HISTORIC LANDMARK COMMISSION
APPLICATION FOR A CERTIFICATE OF APPROPRIATENESS
APRIL 26, 2021
HR-2021-050823
KOHN HOUSE
5312 SHOAL CREEK BLVD.

Construct an addition and landscape modifications at a proposed landmark.

COMMITTEE FEEDBACK

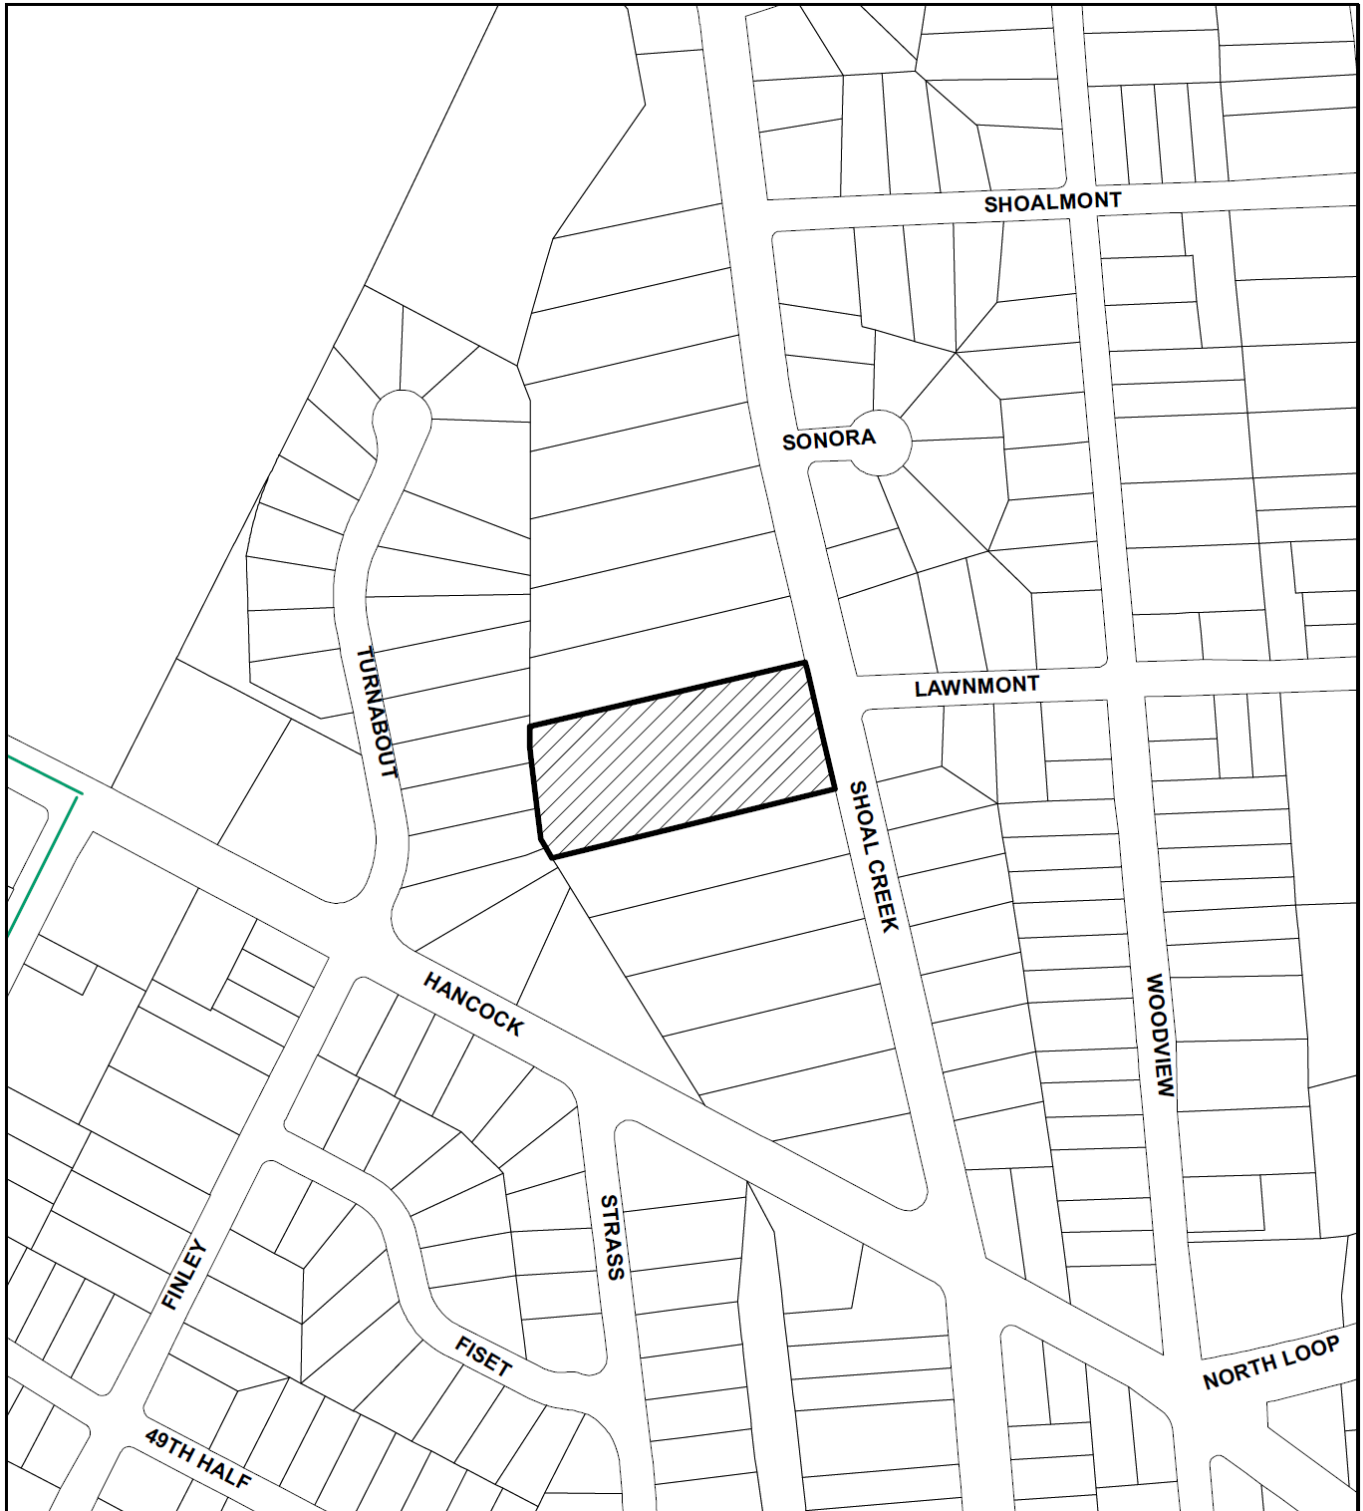
The committee reviewed a previous design set at their April 12, 2021 meeting. Committee members acknowledged that the addition visually recedes based on its complimentary design and dark siding color, but it nevertheless competes with the tower as a primary character-defining feature of the house. Specific concerns include placement of the addition's front wall at the ridge of the side-gabled main roof rather than further back, which inhibits the ability to read the tower as an independent volume. The landscaping plan also is a dramatic change from the natural state of the front yard. The trellis and benches in the front block the main façade. Overall, the committee expressed concerns regarding the applicant's ability to obtain landmark status with the proposed changes.

The applicant has made design changes in response to the committee's feedback, including reducing the overall height of the addition, setting the addition behind the ridgeline of the side-gabled roof, and stepping in the end wall from the gable end. However, these changes are relatively subtle. The trellis is no longer proposed in the front yard.
